SERVICE LETTER 266

MVP-50T Installs on Fire Boss

Aircraft Makes/Model(s):	Float Model(s):	Compliance: Mandatory	By: MAS
Air Tractor AT-802 & AT-802A	Wipaire Fire Boss Conversion (10000A Floats & Landplane)	Part Number: 1012636	Approved: DRH
		Date: 1/6/2025	Revision: B

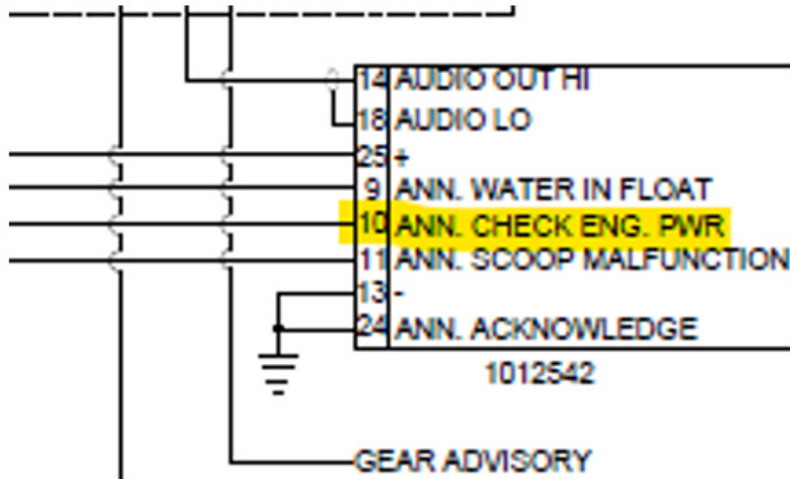
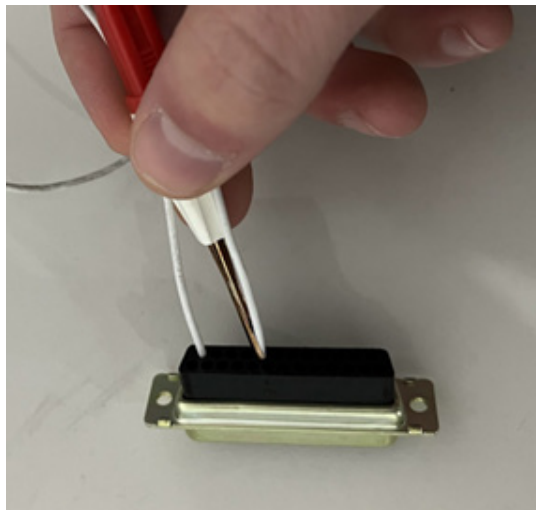
2. Disconnect the 25 pin D-Sub connector from the PRD-60 voice annunciation box and locate the Check Engine Power input, pin 10.

3. Using a D-Sub pin removal tool, remove the Check Engine Power pin from the D-Sub connector. Once removed, properly cap and stow the wire. If a pin removal tool is not available, cut the wire and properly cap and stow both ends.

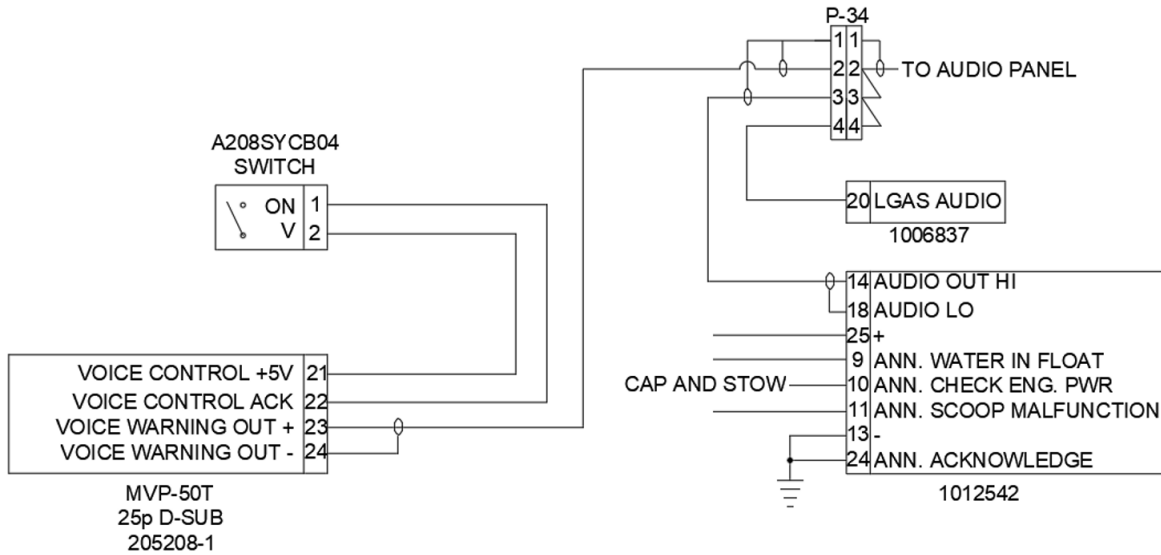
5. From the backside of the light, undo the connector on the wire tail labeled “EXCESS POWER”. Remove the nut on the backside of the light and remove the light assembly with the wire tail.

6. Properly stow the opposite wire lead. Place the nylon hole plug (Item 6) in place of the light assembly. Remove the ENGINE POWER placard and replace it with the new placards (Item 7, Item 8).

Reference the following wire schematic for the following instructions.

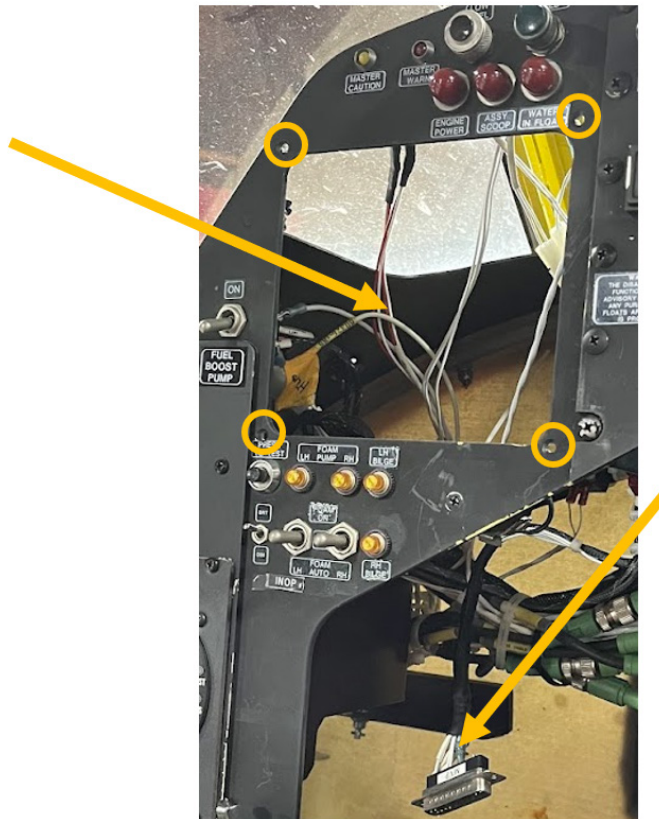
1. Locate and remove the MVP-50T 25 pin D-sub connector. For ease of access, it may be beneficial to remove the MVP-50T display from the panel by removing the four Philips head screws that secure the display to the panel.

2. Unless already installed, wire the Voice Warning Out + (pin 23) into the MVP-50T D-sub connector using a male D-sub pins (Item 3) and shielded wire (Item 1, cut to length). Wire the Voice Warning Out – (pin 24) to the wire shield. (See wiring schematic)
3. Using the provided Molex crimp (Item 4), wire the Voice Warning Out + wire from the MVP-50T into the open pin 2 position on the P34 connector. Both the PRD60 and Wipaire LGAS will have audio outputs going to the same connector. Crimp the wire shield from the PRD60 and MVP-50T together and insert into position 1 on P34. (See wiring schematic)
4. Using 22AWG wire, (Item 2, cut to length) solder the audio acknowledge pins 21 and 22 to pins 1 and 2 on the provided momentary switch (Item 9). Use the heat shrink (Item 5, cut to length) to secure the wires to the switch.

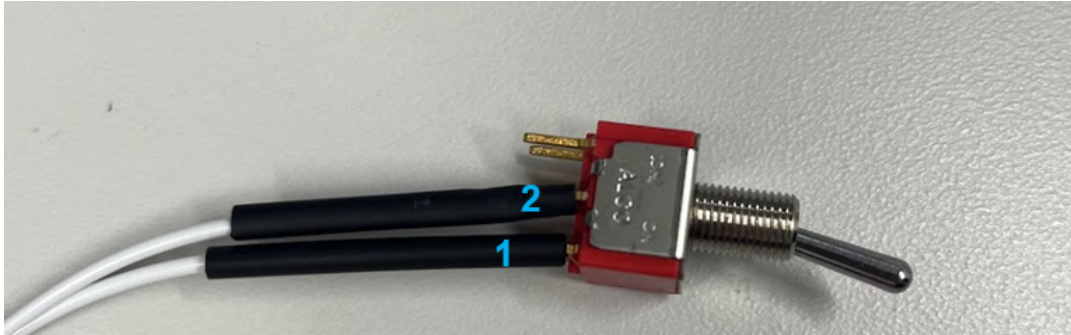
5. Near the Master Caution or Master Warn light, locate a space to install the supplied momentary switch and placards. Ensure ample space to install both switch and placards in proper orientation. Drill a 1/4-inch hole and install the switch with the provided hardware.

6. Install the “VOICE ALARM” and “ACK” placards (Item 10, Item 11) as shown in the image below.
